GRADING AND EROSION CONTROL PLAN
APPALOOSA HIGHWAY 24 SUBDIVISION FILING NO. 2
EL PASO COUNTY, COLORADO

APPALOOSA HIGHWAY 24 SUBDIVISION
FILING NO. 1A
COLORADO SPRINGS, COLORADO
COVER SHEET

Markup Summary

VR 1813

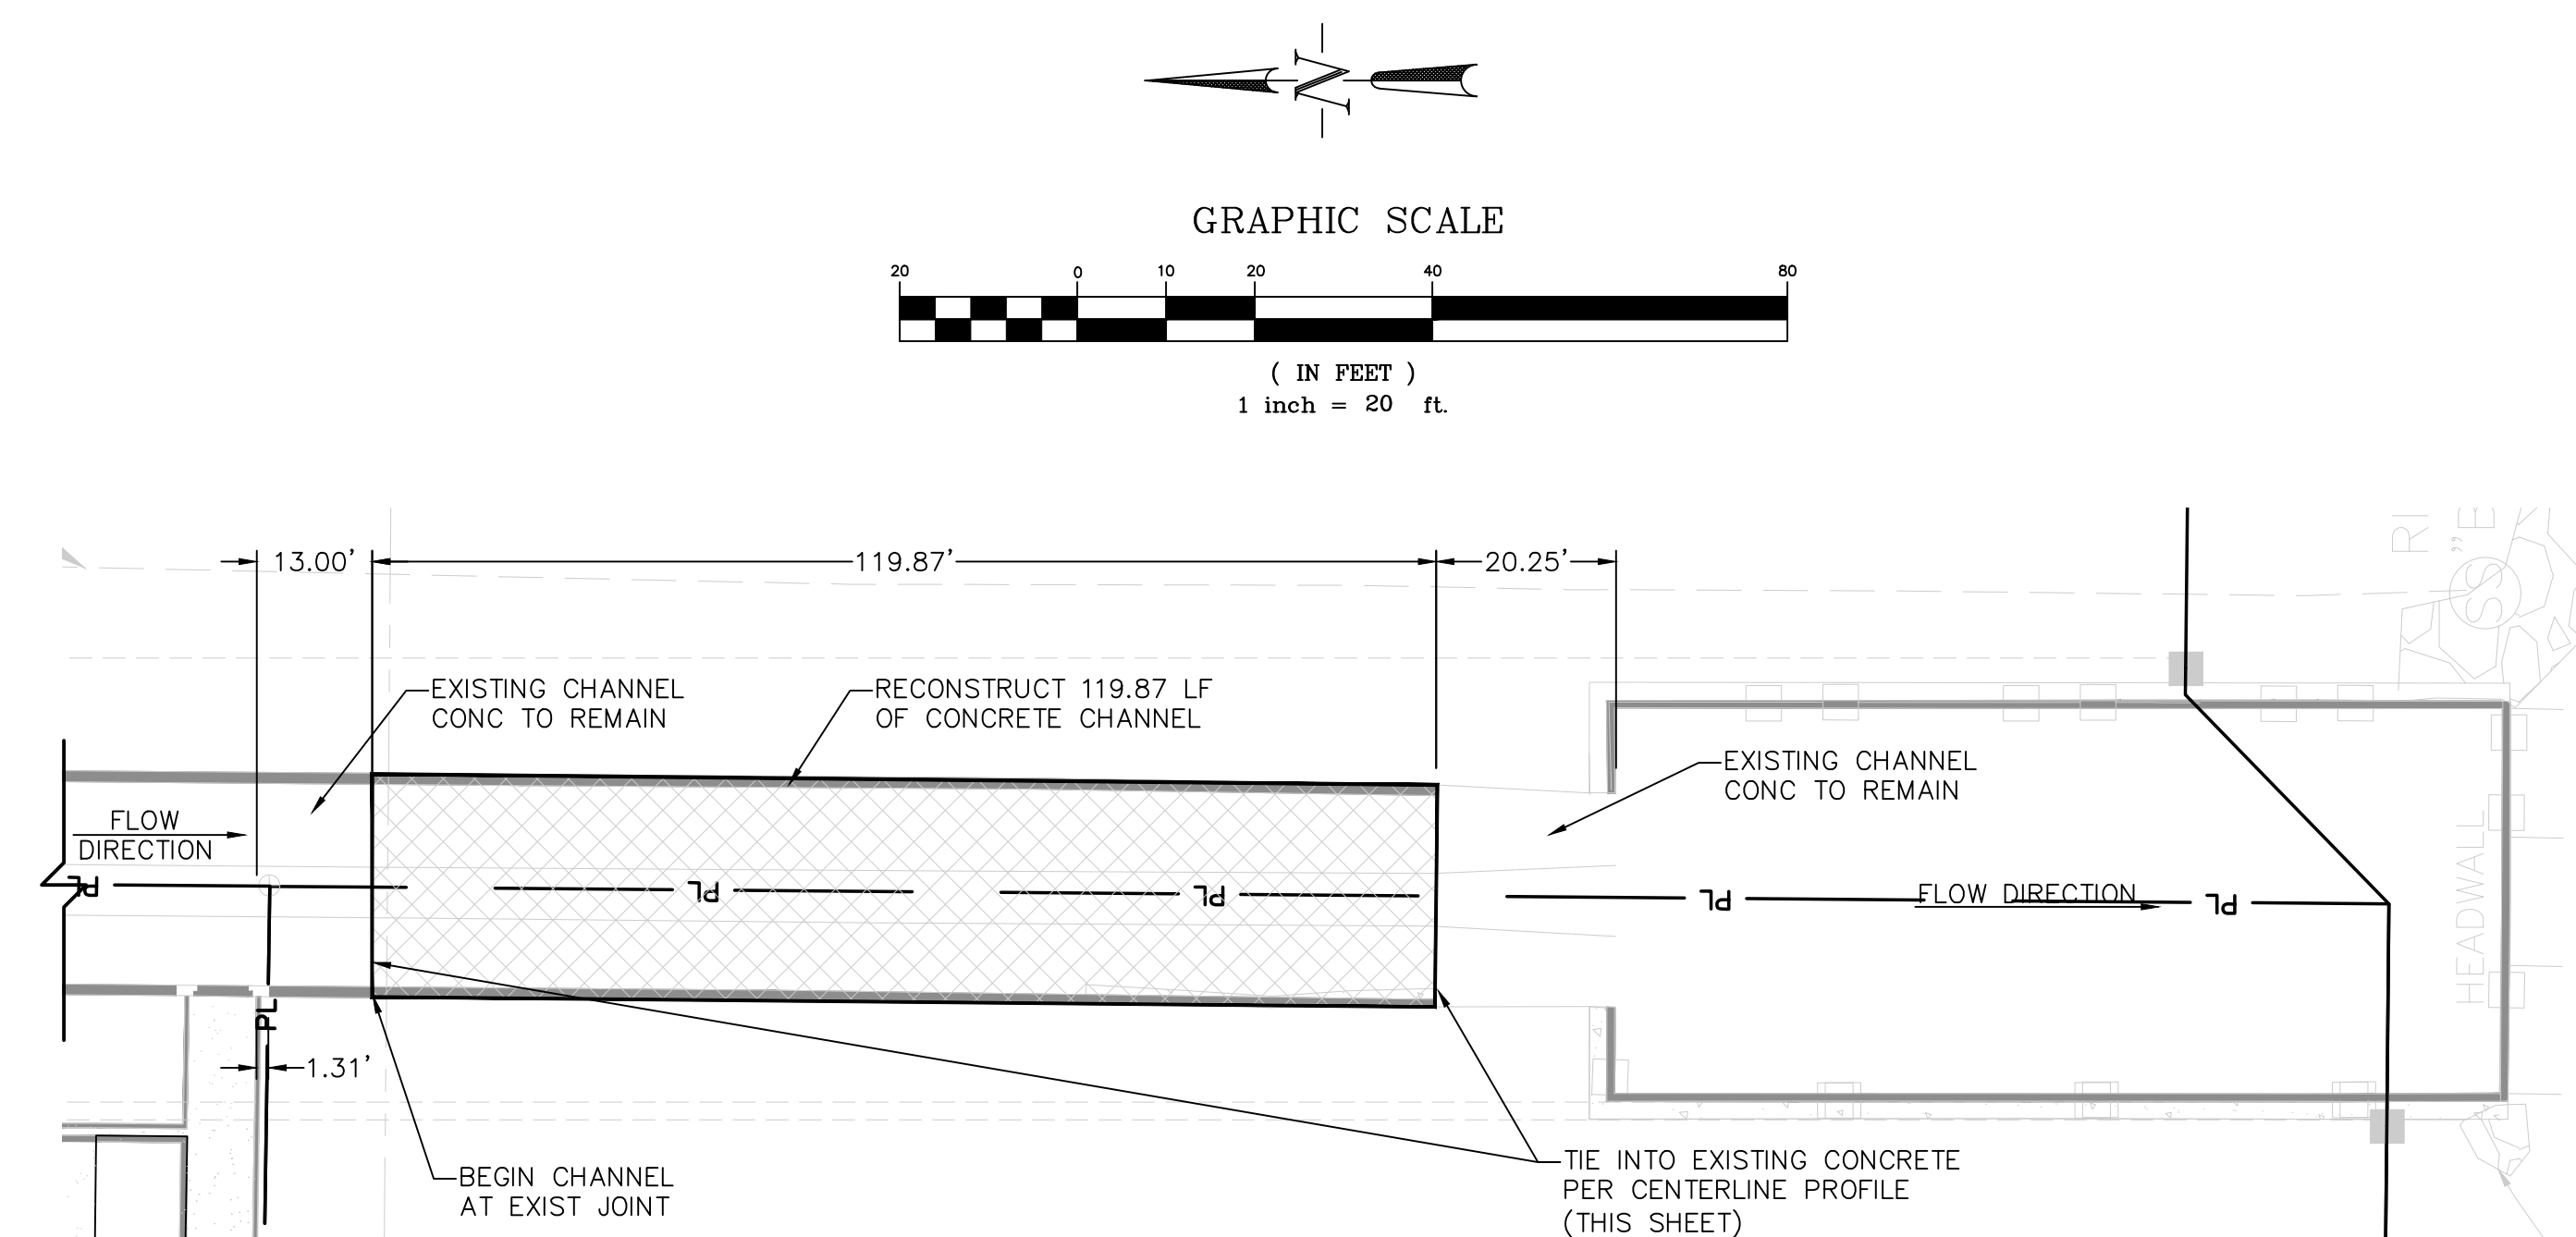
There should not be any "if" statements in the construction plans. Identify here if the design flow is super-critical or not.

What do L1 and L2 represent?

What do L1 and L2 represent?

There should not be any "if" statements in the construction plans. Identify here if the design flow is super-critical or not.
